**Change**

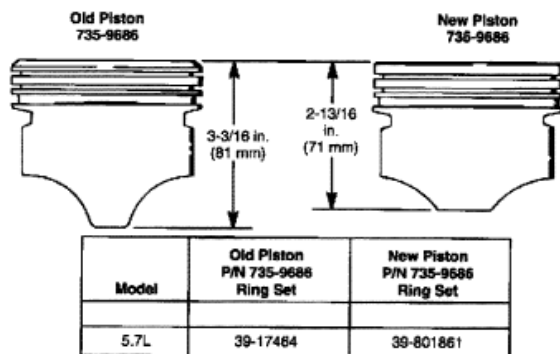
The latest replacement standard pistons (P/N 735-9686) for these engines use a different set of piston rings. The latest piston's oil ring groove is not as deep as the older piston.

If piston rings only are required, refer to the drawings before ordering replacement piston ring sets from the chart.

The latest replacement piston will be shipped with a set of piston rings.
